**COON CREEK WATERSHED DISTRICT
Request for Board Action**

MEETING DATE: February 12, 2024
AGENDA NUMBER: 12
ITEM: SP 0208-165

Permit Application Review Report
Date: 2/8/2024

Project Name: SP 0208-165

Figure 1: Site Plan

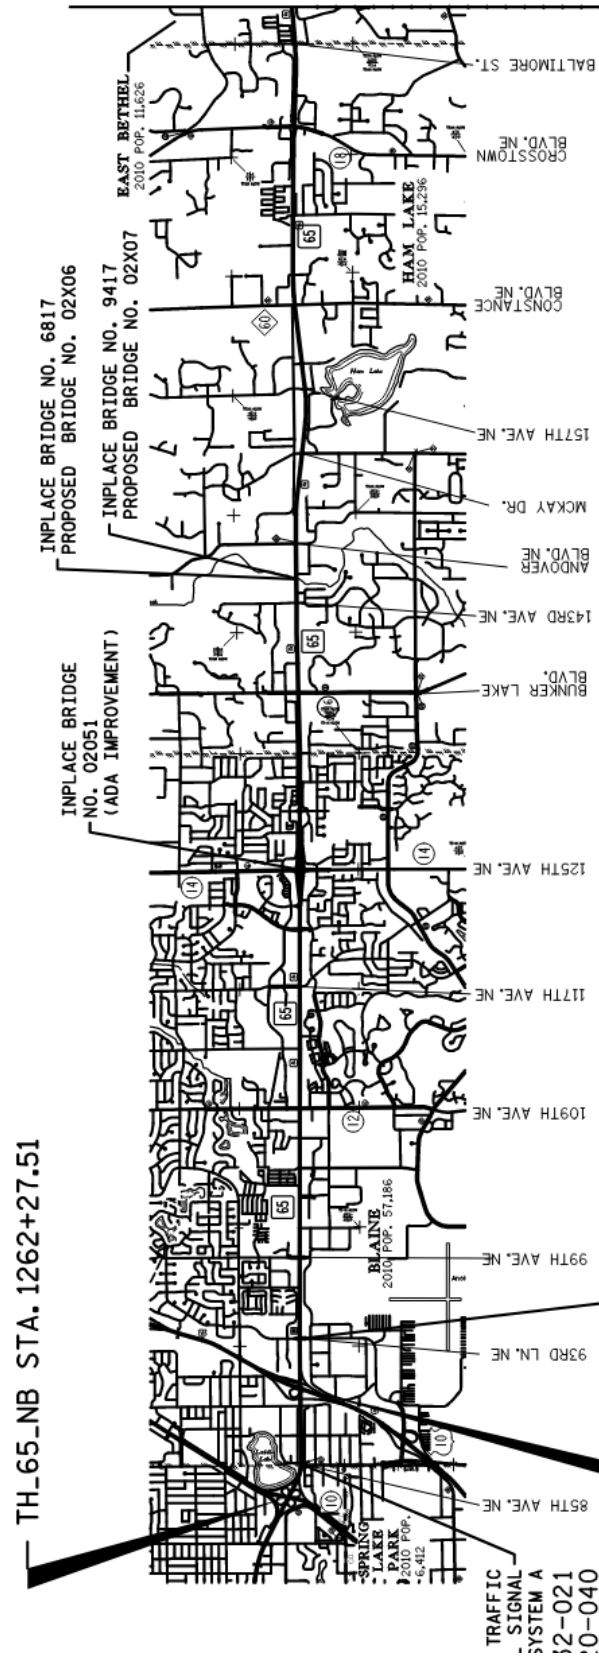
Description: The project scope is proposed largely in preparation for an upcoming large road project along the same corridor. This project includes in-kind replacement and repairs to existing culverts along HWY 65 from CSAH 10 through the northern boundary of the Coon Creek Watershed District, construction of temporary new road surfaces, and the replacement of the bridge over Coon Creek with culverts. The total project disturbance is 8.26 acres. There is no permanent new or reconstructed impervious proposed. See Figure 1: Site Plan (attached).

Figure 2: Erosion and Sediment Control Plan

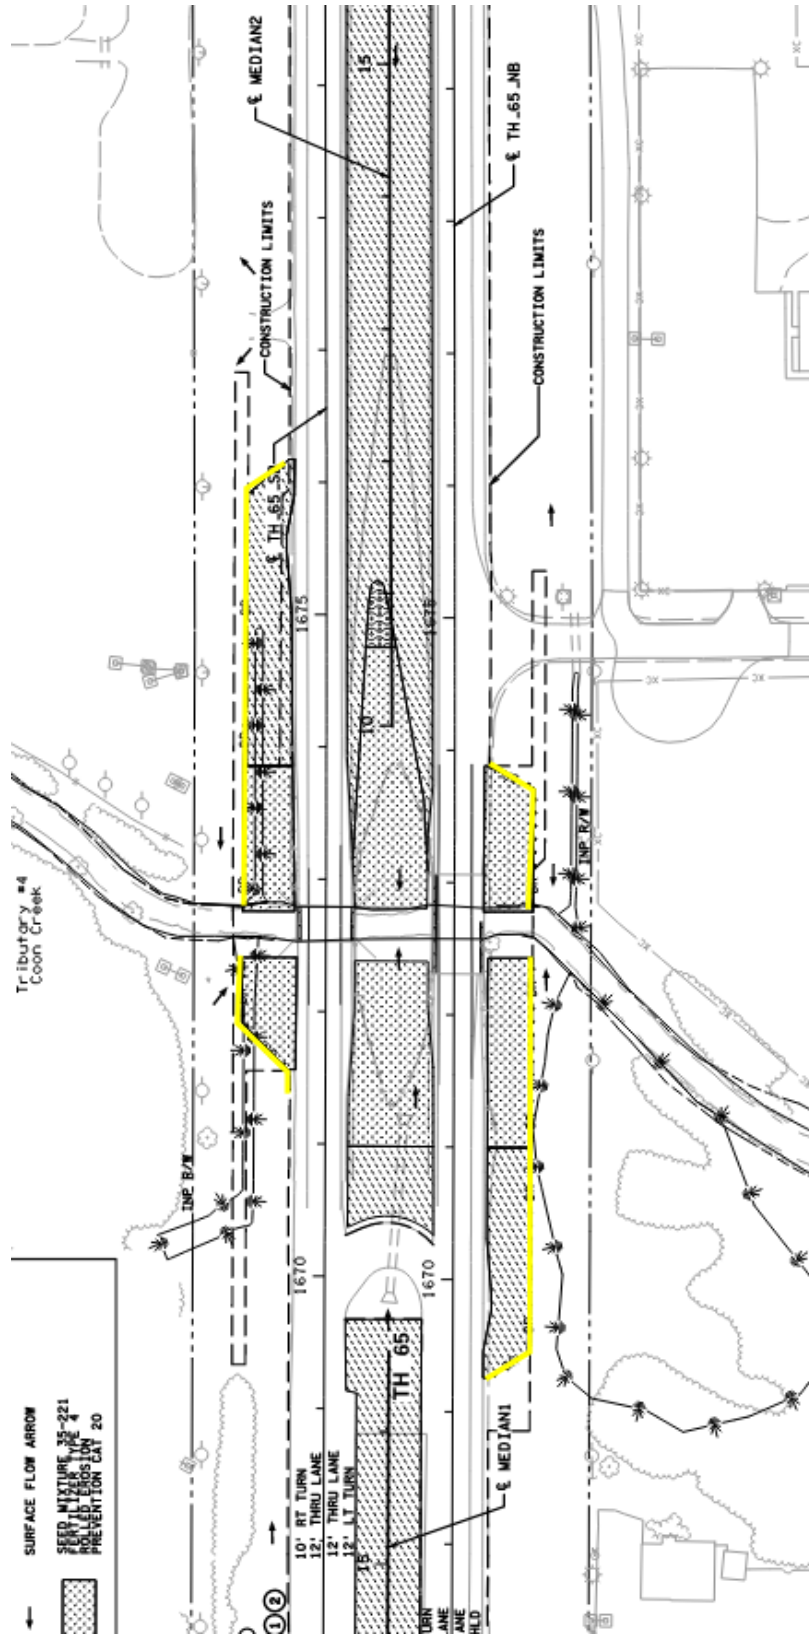
Minor portions of work take place within several subwatersheds. The bridge replacement portion of this scope of work is located within Coon Creek. The soils affected by the project include Zimmerman and Seelyeville. Disturbed areas are proposed to be stabilized within 7 days, as required. The proposed erosion and sediment control plan includes perimeter control, rip rap, and seeding. The erosion control plan meets District Requirements. See Figure 2: Erosion & sediment control plan (attached).
